PROPOSAL:

- **Development Permit**
- **Development Variance Permit**

LOCATION: 15200 Guildford Drive

Response to ADP-2023-10-26 File No. 21-0153

Ld-4 6' High Privacy Screen
L-1.1 SCALE 1"=1'-0"

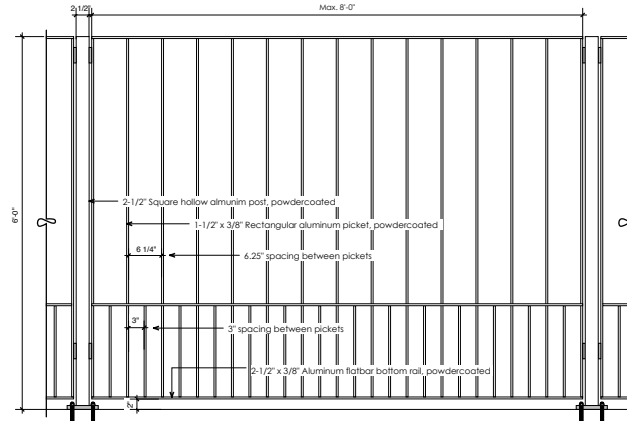
- Consider providing additional buffer between neighbouring buildings and the walkway on south. A fence along the walkway is to be added; additional planting to be considered. Note that the pathway design has been created at request of neighbouring property.

Ld-3 Outdoor kitchen on Rooftop
L-1.4 SCALE 1/2"=1'-0"

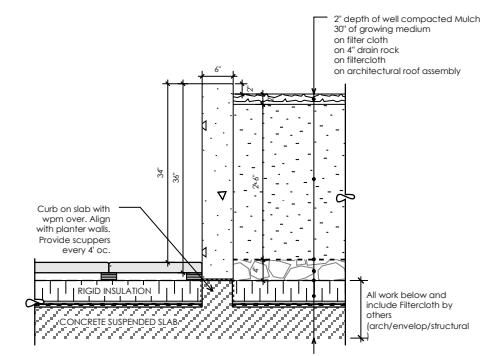
- Consider the addition of seating pods in the outdoor kitchen area to provide more space for small groups and individuals. Bar top tables and stools to be added in outdoor area.

- Consider the addition of a barbecue in the outdoor kitchen area, and similarly, a counter tops and functional cooking spaces. BBQ located in outdoor kitchen area is already present on provided ADP drawing set.
